Title Face Detection Attendance Machine iF11		
Size C	Number	Revision
Date: 1/04/2025	Sheet of	
File: D:\Alitum\iF11M.SchDoc	Drawn By:	Bhu

LCD LDO

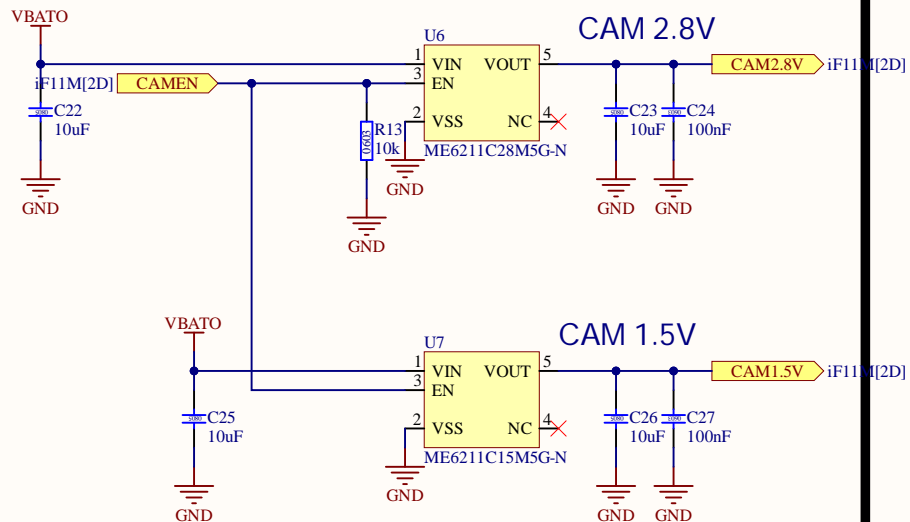
LCD LDO should be 2.8V for safer operation

Battery Charging & Protection

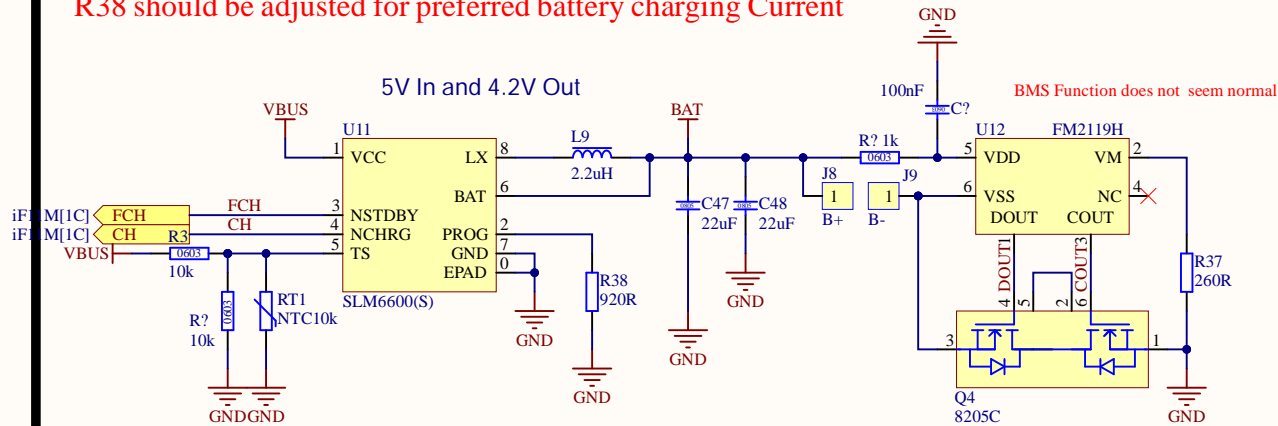
R38 should be adjusted for preferred battery charging Current

BMS cuts power at 2.4V which is unnecessary. BMS should be changed or removed

Wireless Charging

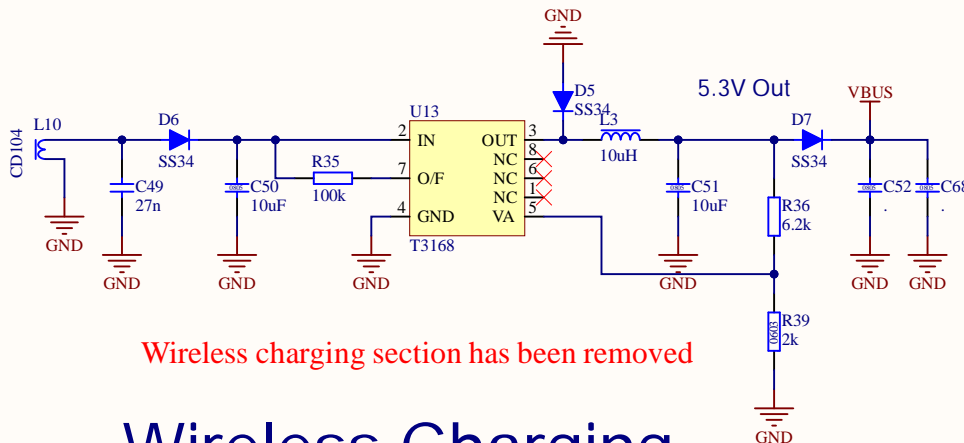
Wireless charging section has been removed

TFT 2.8" LCD

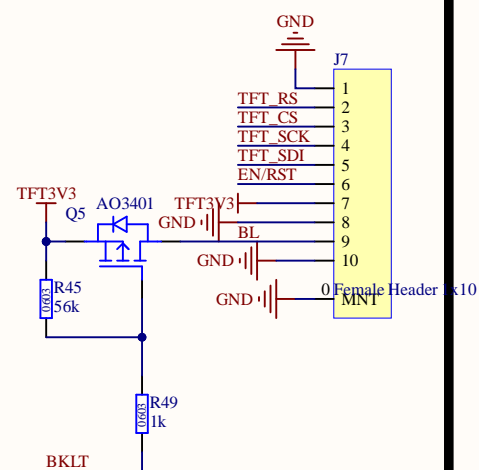
Less than 3V decreases the screen brightness significantly
